**Response to Submissions Report  
REMONDIS Australia Pty Ltd  
Tomago Resource Recovery Facility and  
Truck Parking Depot (SSD-10447)**

Report version	Authors	Date	Reviewer	Approved for issue	Date
DRAFT	R. Loemker, and Dr M. Jackson	19/05/21	Dr M.Jackson	Dr M.Jackson	20/05/21
FINAL for issue to DPIE	R. Loemker, and Dr M. Jackson	07/06/21	Dr M.Jackson	Dr M.Jackson	08/06/21

**Figure 5.1 – Wash Bay located in Proposed Heavy Vehicle Workshop (21D School Drive).**

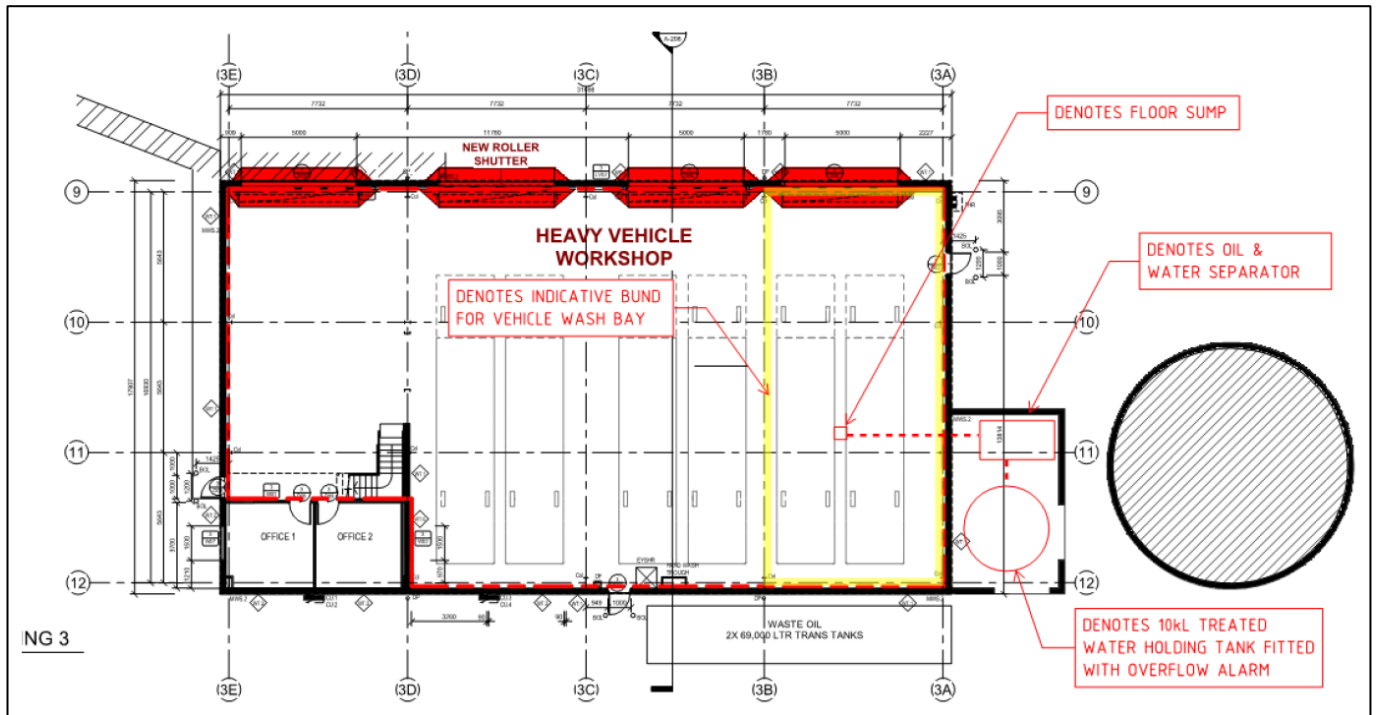
A vehicle washdown bay is proposed to be installed within the heavy vehicle workshop (refer to Figure 5.1 below).

The vehicle washdown bay will be bunded internally within the building with proposed screens to be installed to ensure full water capture. Run-off from the truck wash will be collected by existing floor sumps that will drain the water to a pit in the shed on the northern side of the maintenance workshop. Water will be treated in an oil/water separator and pumped to a 10kL holding tank also located in the shed. The tank will be periodically pumped out, with treated water sent for off-site recycling in accordance with Remondis’ existing tankering agreement with Hunter Water Corporation.

**Figure 5.2. Indicative Pavement Detail.**

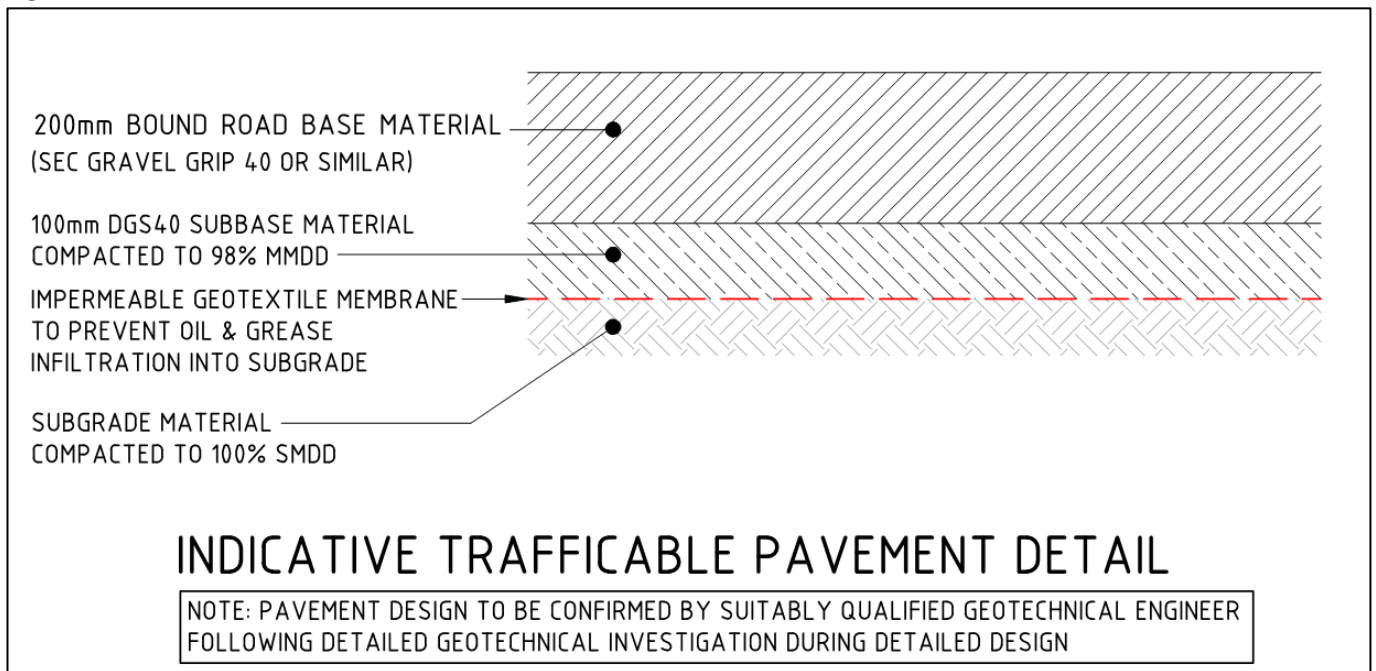
Despite the subsequent findings in the groundwater assessment, a capping layer has been proposed for the extent of the new parking depot to achieve two primary objectives. The first is to maintain consistency with the outcomes of the Remediation Action Plan, and the second, is to prevent ingress of additional pollutants that may occur from the truck parking depot (for example small oil leaks or spills).

Figure 5.2 presents the proposed pavement design extracted from the revised engineering plans prepared by Northrop for the parking area, composed of 200mm bound road base material with an impermeable geotextile layer.

The pavement will fall towards stormwater pits where water will be captured, treated, and directed to the infiltration system. The hydraulic conductivity of the road pavement layer is not critical due to the presence for the impermeable geotextile layer. Any surface runoff not captured by the pavement layer will flow as surface runoff and be collected via the stormwater pits installed within the pavement extents. The runoff generated from surface overland flow and the stormwater collected by the subsoil drainage system are directed to the same discharge location after processing through the treatment train.

Figure 6.1. Tomago Resource Recovery Facility and Truck Parking Depot – updated notification plan (Plan A-020).

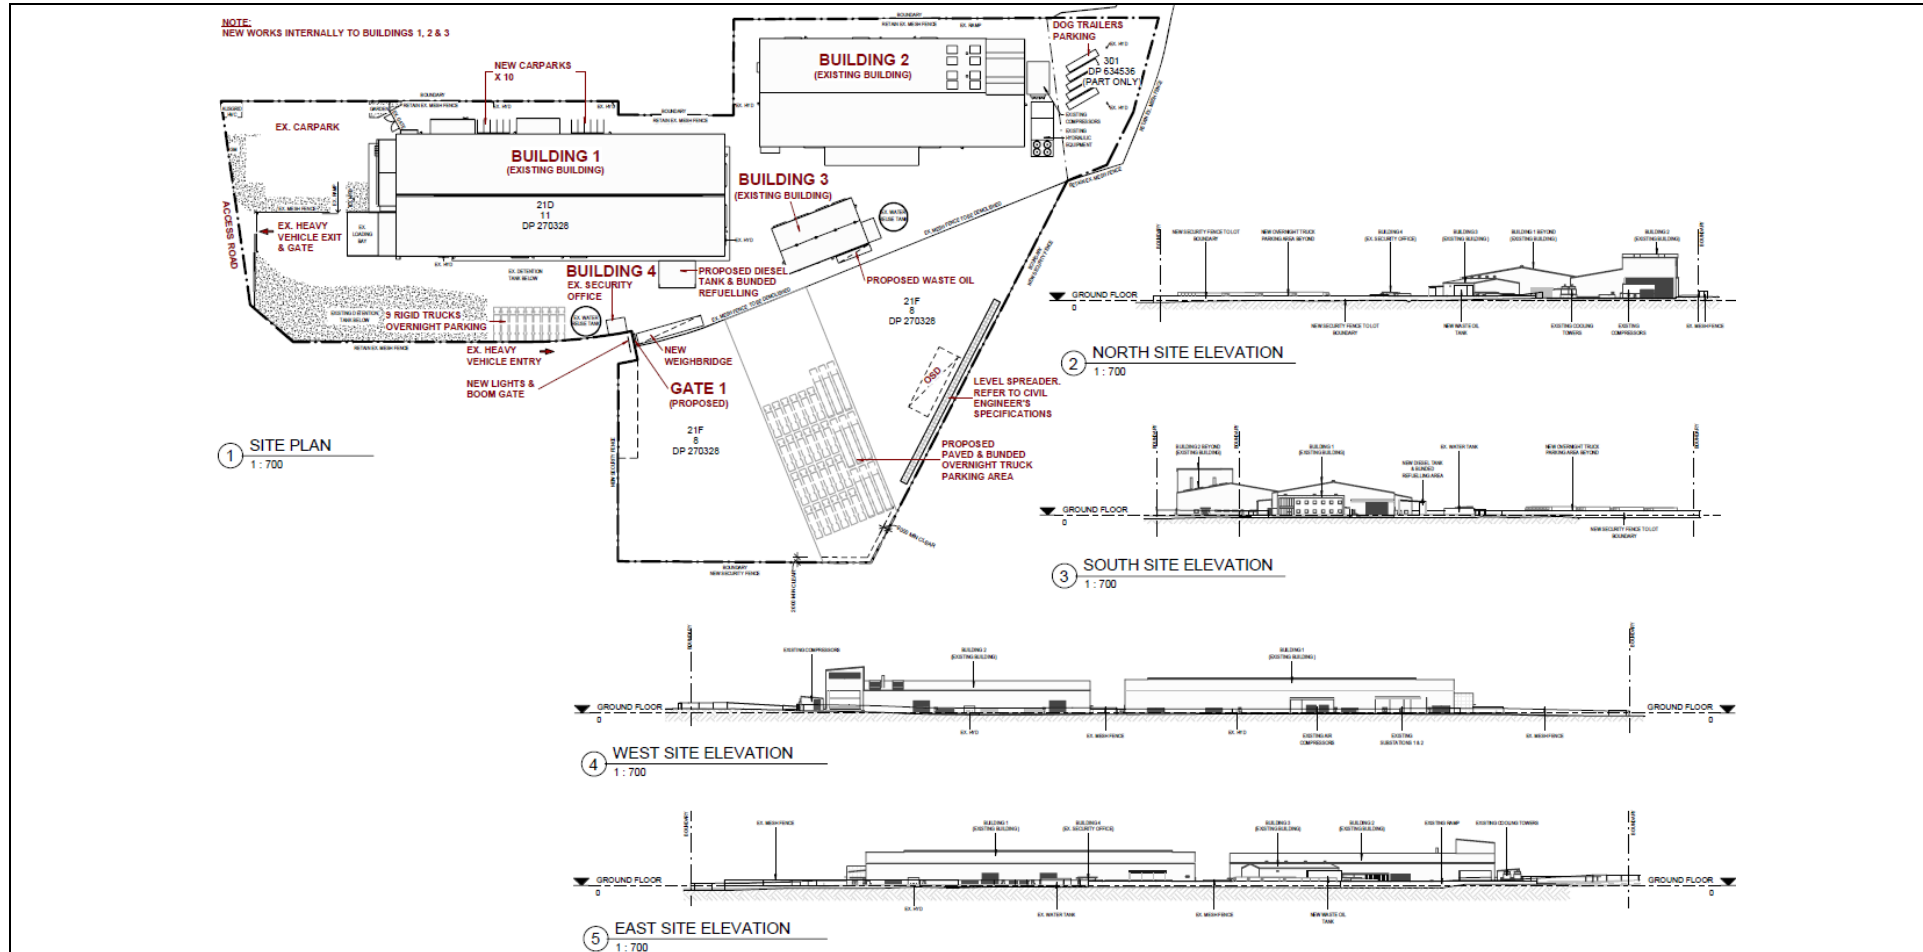
- Level spreader shown on the notification plan (Plan A-020);
- Full bunding shown on General Arrangement plan for Building 2 (Plan A-102A);
- Note on Building 2 Detailed Plan that full building bunding is to be provided (Plan A-102B); and
- Floor plan for Building 3 (Plan A-103) amended to show features for the truck wash in the Heavy Vehicle Workshop, including:
  - 10KL treated water holding tank fitted with overflow alarm;
  - Oil and water separator;
  - Floor sump; and
  - Bunding.

Figure 6.4. Tomago Resource Recovery Facility and Truck Parking Depot – Updated general arrangement plan for Building 3 (Plan A-103).

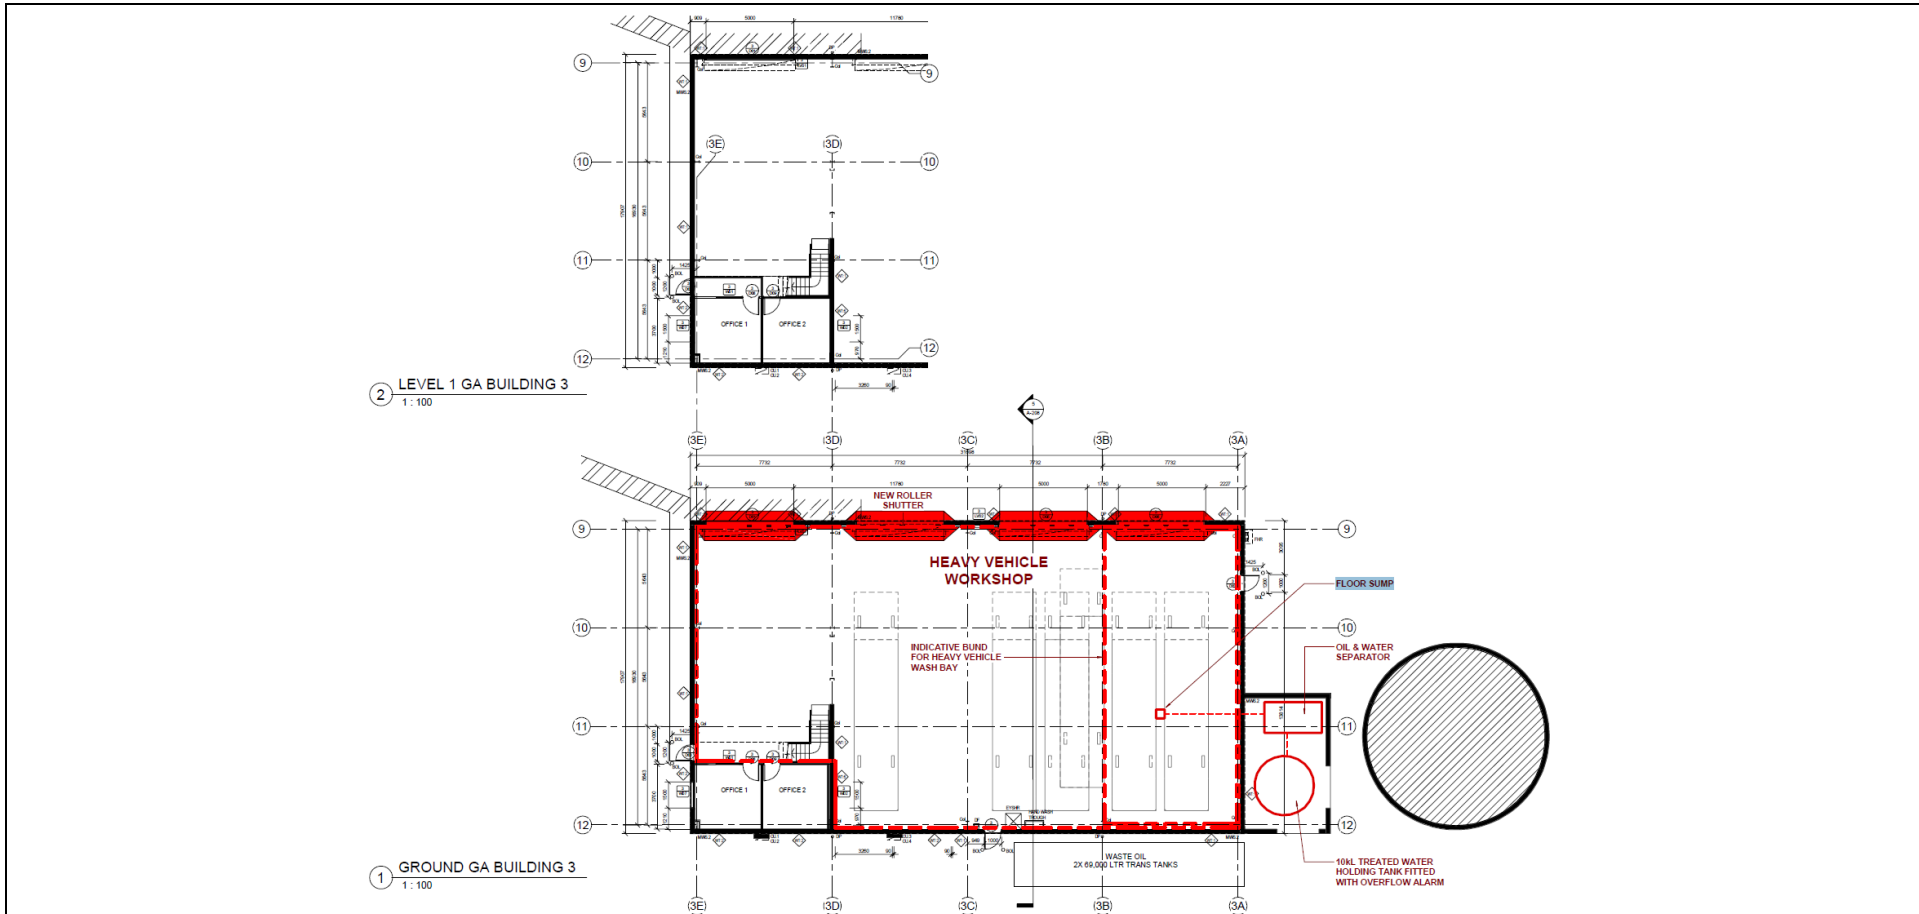
There are no proposed significant changes to the project. A formal vehicle washdown bay is proposed to be installed within the heavy vehicle workshop (refer to Figure 6.4 below). Two vehicle bays will be bunded internally within the building with proposed screens to be installed to ensure full water capture. Run-off from the truck wash will be collected by new floor sumps that will drain the water to a new holding tank adjacent to the existing sewer system. Figure 6.4 illustrates the indicative bunding and wash bay within the workshop.
